**PROPOSED SENIORS HOUSING DEVELOPMENT STAGE 3
COPPERFIELD DRIVE, ROSEMEADOW NSW 2560**

**BUILDING CODE OF AUSTRALIA 2019 AMENDMENT 1 REPORT
APRIL 2021**

Report reference 20200R03

Date 14th April 2021

Exposure to a fire source feature

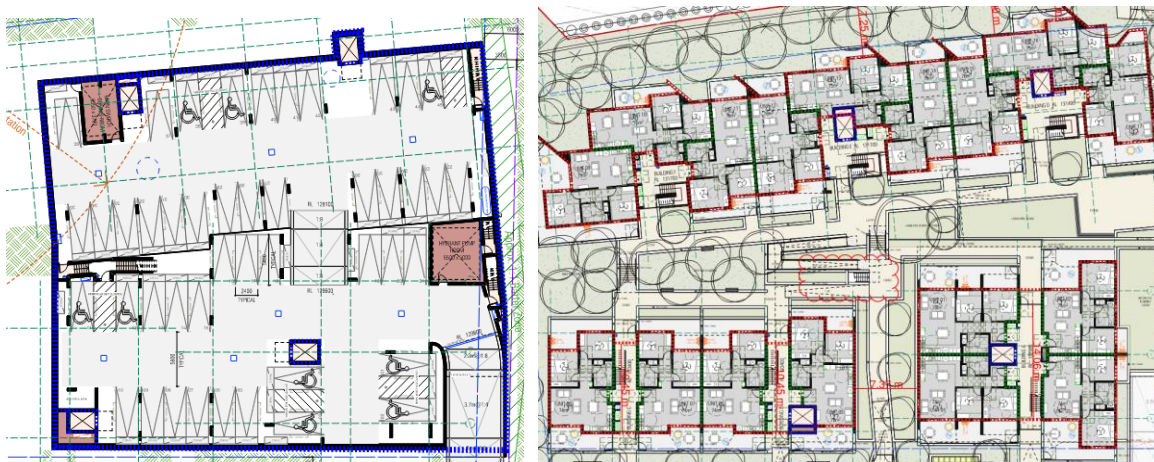
- Basement level – External walls to have a FRL of 120/60/30 shown in blue below
- Ground Level to Level 2 – External walls to have a FRL of 90/60/30 shown in red below

Internal fire rated walls (eg apartment bounding walls)

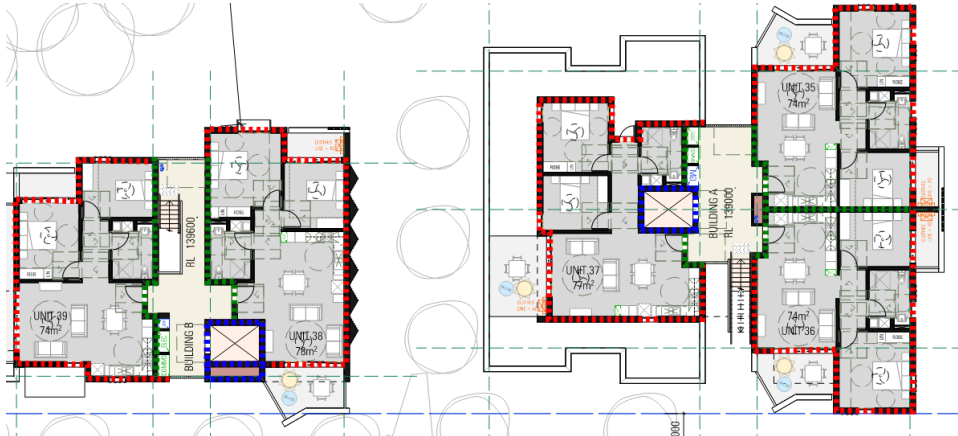
All internal walls bounding and separating the proposed apartments are to achieve a FRL of 90/90/90 shown in green below for reference. All internal fire rated walls must extend to—

Compliance readily achievable and to be documented in the Construction Drawings. Architect to provide plans showing the FRL's to the walls separating and bounding the apartments. Additionally, details of the relationship between the walls and the roof are to be detailed prior to the issue of the relevant Construction Certificate.

Floors

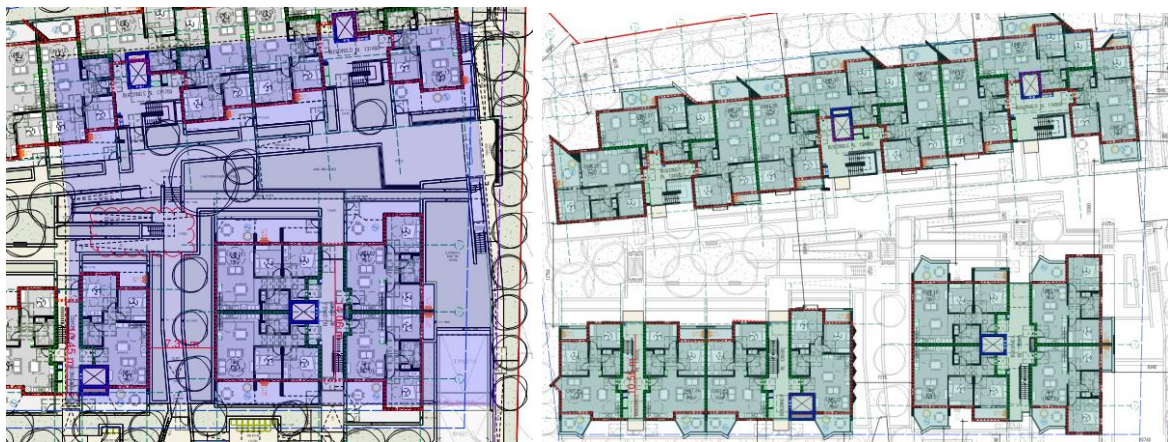
- Floor between basement and ground level – 120/120/120 shown in blue below
- Apartment levels – 90/90/90 – shown in green below

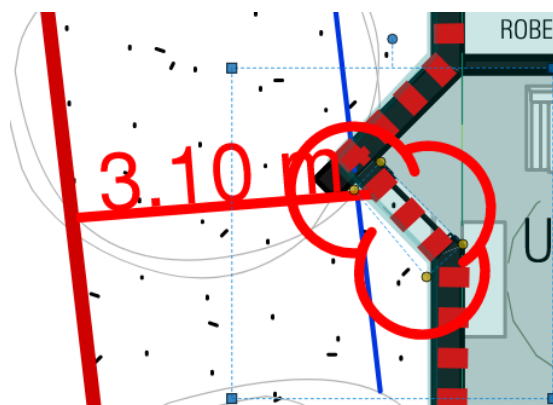
The corridors are open and not bounded by construction and are therefore not considered as enclosed and are not required to be smoke separated in lengths of 40m.

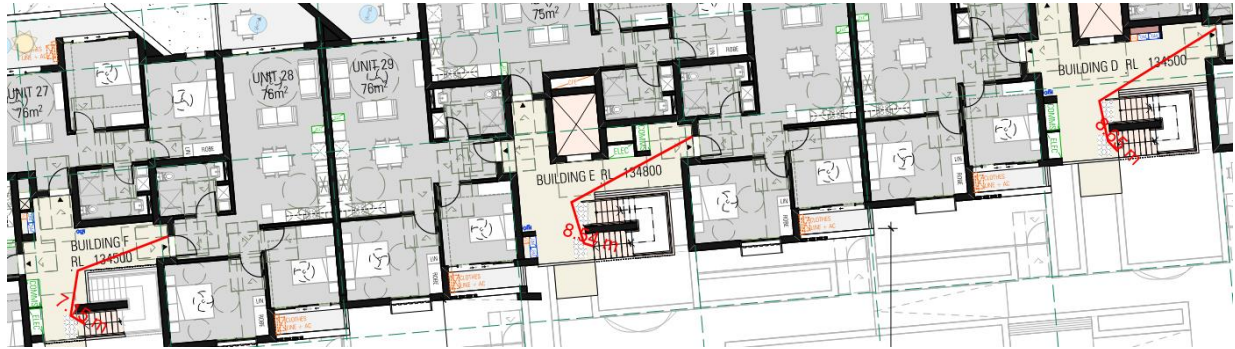
- Building A – complies
- Building B – approx. 9m to an exit in lieu of 6m
- Building C – approx. 8m to an exit in lieu of 6m
- Building D – approx. 9m to an exit in lieu of 6m
- Building E – approx. 9m to an exit in lieu of 6m
- Building F – approx. 8m to an exit in lieu of 6m

A Fire Engineered Performance Solution will be required to be provided where re-design is not possible. Fire Engineer to include in the FER and provide further details prior to the issue of the Construction Certificate.

Second Floor

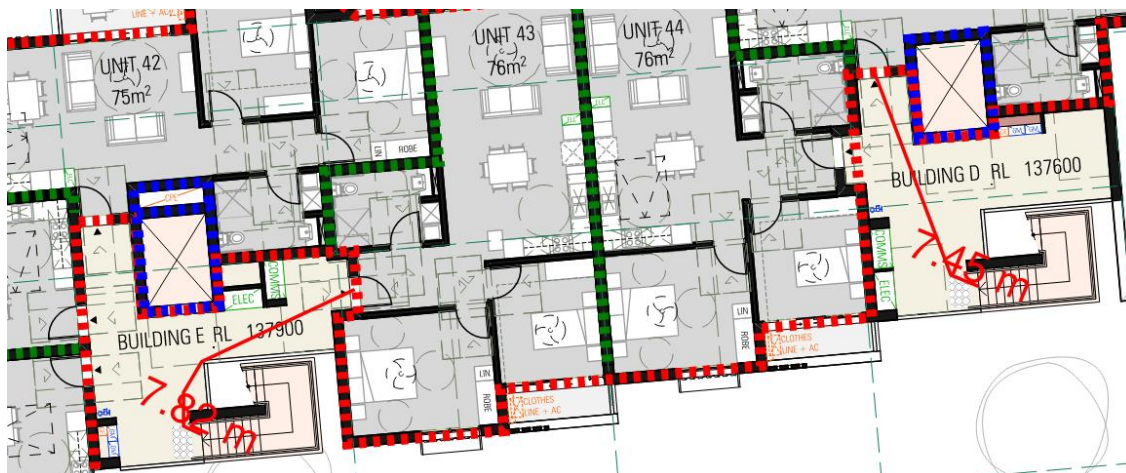
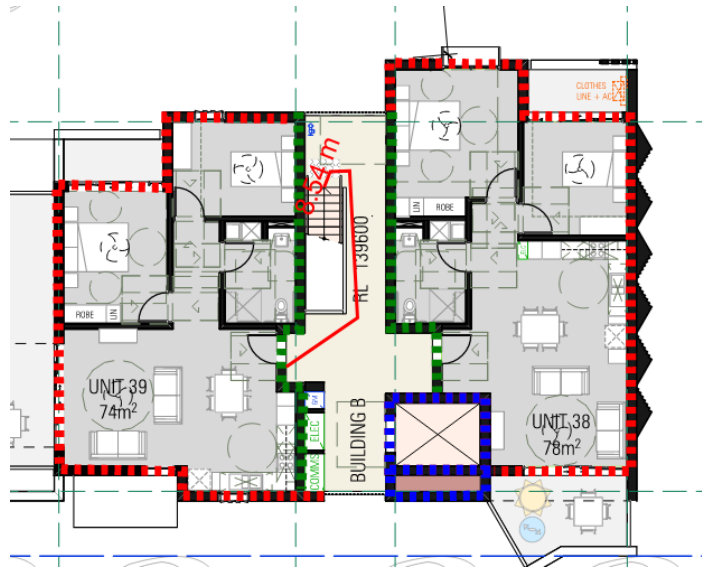
- Building A – complies
- Building B – approx. 9m to an exit in lieu of 6m
- Building C – N/A
- Building D – approx. 8m to an exit in lieu of 6m
- Building E – approx. 8m to an exit in lieu of 6m
- Building F – N/A

A Fire Engineered Performance Solution will be required to be provided where re-design is not possible. Fire Engineer to include in the FER and provide further details prior to the issue of the Construction Certificate.

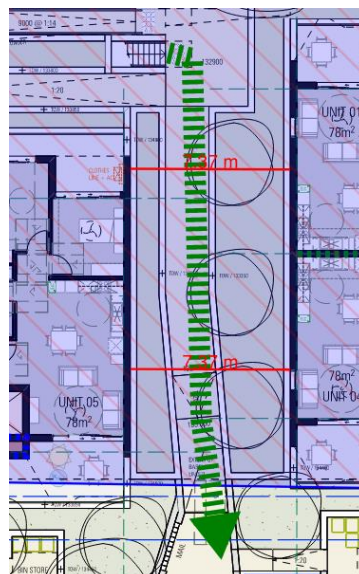
Note that the basement stairs currently discharge to the roof of the carpark, and therefore the slab above of the carpark must achieve a FRL of 120/120/120 as shown below. Structural Engineer to validate the car park roof will comply.

The path of travel from the roof to open space between buildings A and B currently comply, however there is little tolerance allowed between the two buildings. This will need to be checked progressively throughout the design. Where openings encroach within 3m of the path of travel, they will need to be relocated or a performance solution will need to be considered.

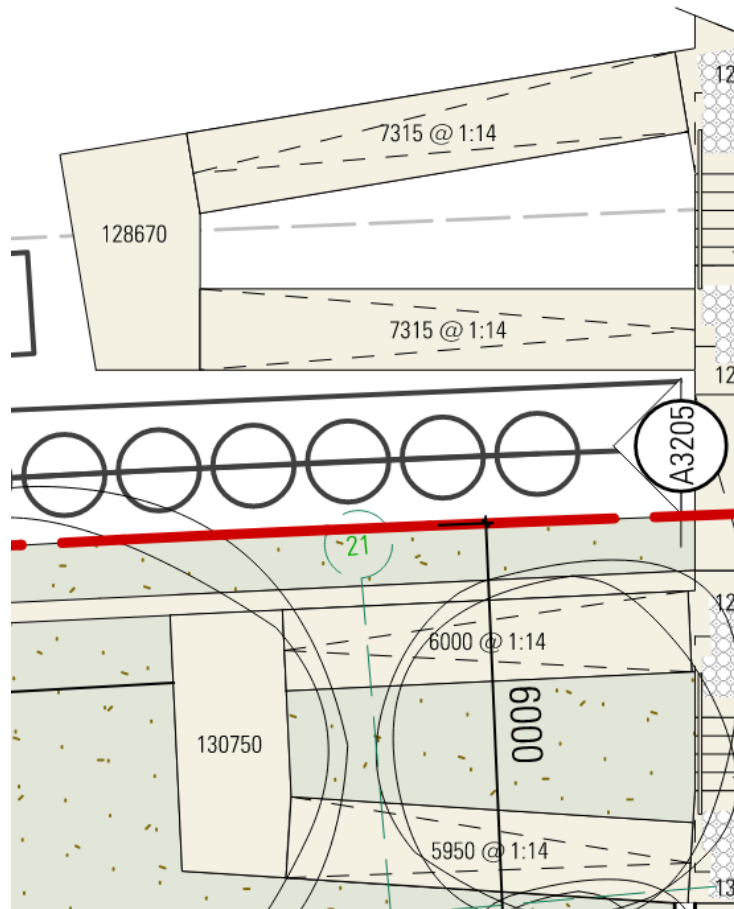
Architect to note and show handrails and kerbrails to the proposed ramps shown below

Compliance readily achievable. Architect to note and provide further details of the ramp, its handrails and kerbrails prior to the relevant Construction Certificate.

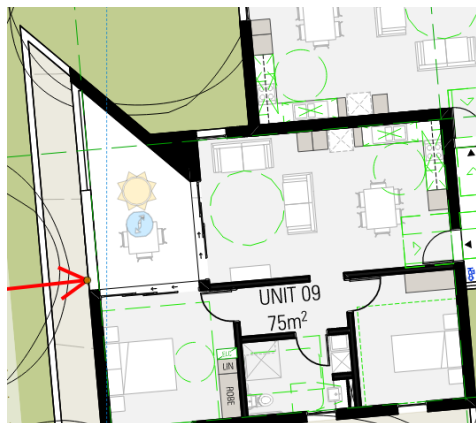
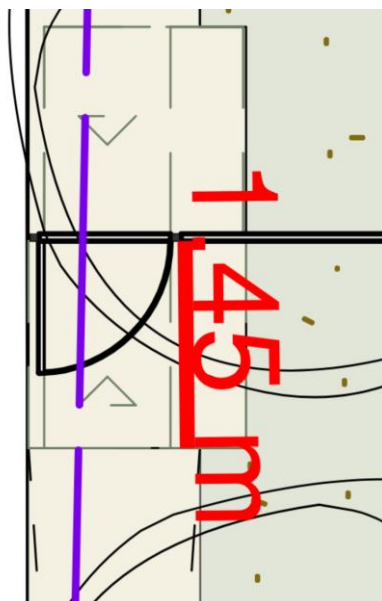
Architect to note the landing to the external gate at the western end of the complex does not achieve a minimum of 1540mm circulation length and the plans will be required to be amended to comply.

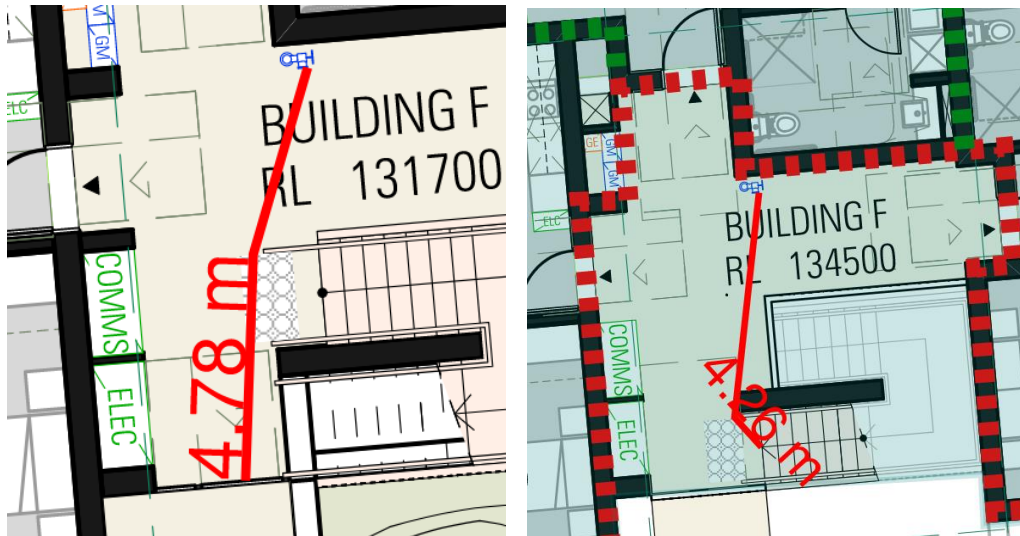
Architect to note and amend the plans to show the internal hydrant points to be outside the non-fire isolated stairs and within 4m of the exit within the basement level.

Architect to note the internal hydrant serving Building F on ground floor and Level 1 is not within 4m of the required exit. Note the required exit on the Ground floor point is the door providing egress to open space. Please amend the plans to comply.

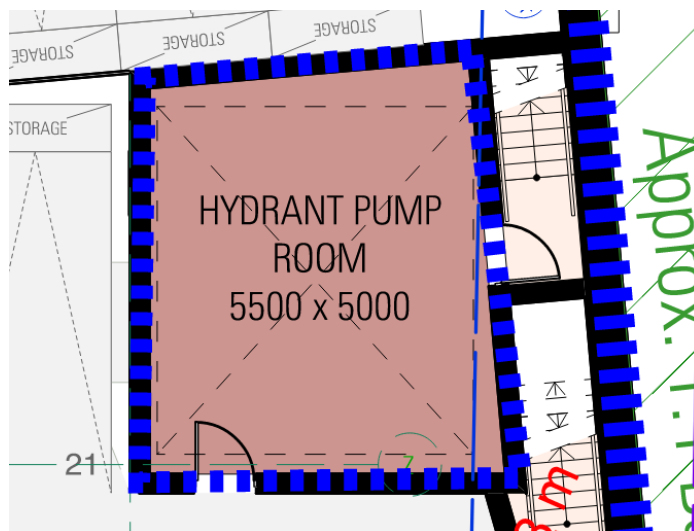
The hydrant pump room does not open into a fire-isolated stair, nor does it open out to open space. Architect to note the non-compliances and amend the plans to comply. Where redesign is not possible, a fire engineered performance solution may be considered.
